Ultralight Concept srl Avenue des Biolleux 7a 4800 Verviers Belgium

## **ALERT**

Number: SV4-RS-AB01 Original issue: 07 JUL 2021

SUBJECT: main landing gear, part 405B control/modification

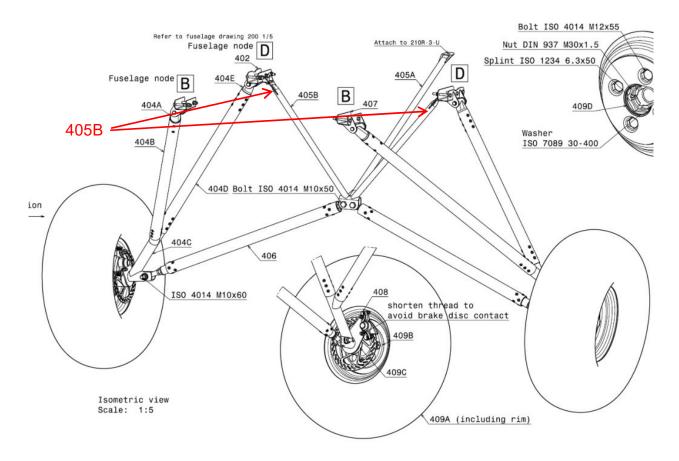
On a SV4-RS totalising something more than 400 hours, the triangular strut (part number 405B, see picture below) of the main landing gear broke on one side of the attachment points after landing. The construction however permitted to taxi back to the hangar without difficulties. There were no injuries and no other damages on the aircraft.

As a result of thorough investigation, it appeared that the parts broke due to a fatigue failure on one gusset of part number 405B of the main landing gear.

Up to then, we ask you to survey the main landing gear in-depth before and after every flight. If part 405B of your aircraft shows a fissure or a crack on the gusset shown on the picture hereafter, we will provide the old version that has equipped every SV4-RS until now, to permit you to continue flying until the new parts are ready to be delivered.

Part 405B must be changed at the latest when the first crack appears in the paint of the gusset (see picture below).

Part 405B will have to be changed on every SV4-RS, once the parts will become available. Right now, we started production of a sufficient number of parts to supply every customer. The customers that have their aircraft flying will be served first. Disassembly and assembly instructions will be provided with the parts.
